Technical Bulletin / Safety Alert

Unique ID No: GEN2008-TBSA-03 **rev:** 0

Subject: Operator Covered in Hydraulic Oil

Applicable to: All JUG-A-0 UL/UV "V1" & "V2" Machines

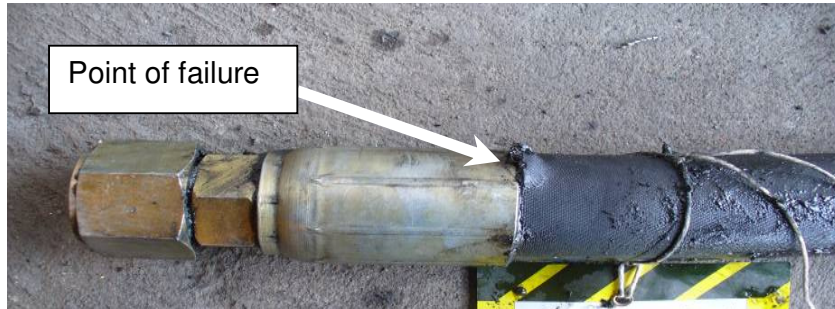
A nightshift operator was operating a JUG-A-0 when a hydraulic hose blew behind the ferrule and sprayed hydraulic oil through a hole in the cover and covered him in the oil. The hose contains a maximum working pressure of 2700 PSI. The cover is shown below and point of failure is indicated.

As the system has the capability of going to 2800psi the hose that failed is under rated & should not be used. The failed hose has ruptured at the end of the ferrule where it has either "worked" through, its length was too short, or the assembly process was incorrect. These are all possible causes that could lead to hose failure.

Cover at least the first 300mm of this end of the hose with burst sleeve.
